**ADDRESS: 627 N 16TH ST**

Proposal: Construct addition

Review Requested: Final Approval

District Designation: Spring Garden Historic District, Contributing, 10/11/2000

**A402**

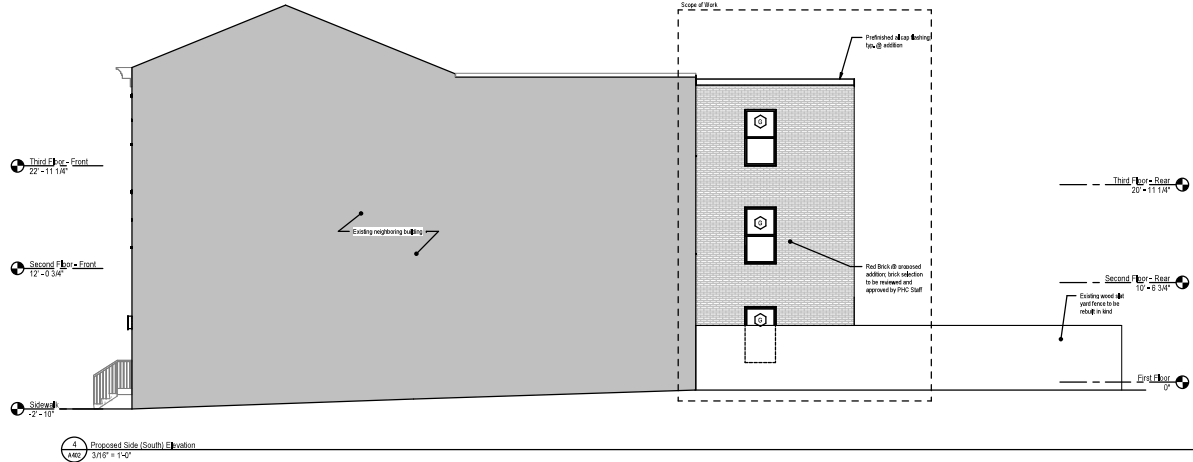
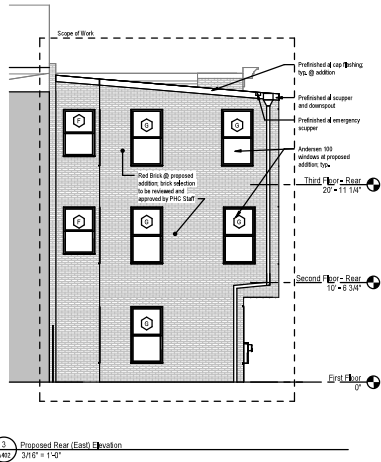
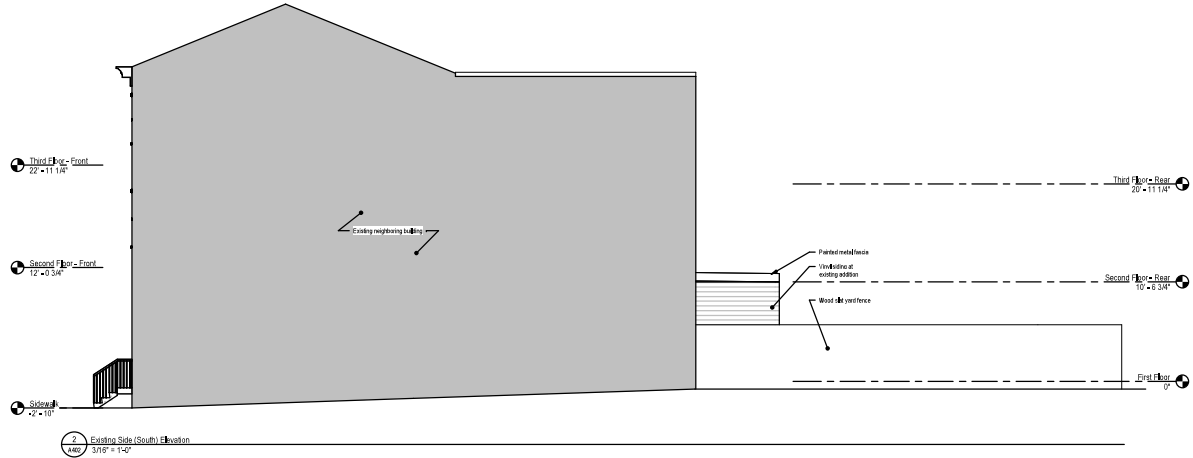
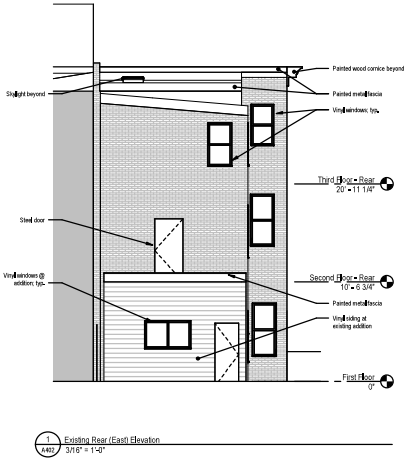
- The proposed fiber cement panels on the north and east walls of the addition do not meet Standard 9. The material is not compatible with the historic materials or features of the building. The cladding should be replaced with an alternate material like lap siding that is more appropriate for a rear addition on a historic building.
- The proposed basement egress well will satisfy Standard 9 if the window is designed to include a horizontal mullion at the position of the former sill so that the upper piece of glass replicates the size and proportion of historic basement window.

**STAFF RECOMMENDATION:** The staff recommends approval, provided the cladding material is changed to a lap siding instead of panels for the north and east walls of the addition and the front egress window is designed to appear like the historic basement window above grade, with the staff to review details, pursuant to Standard 9.
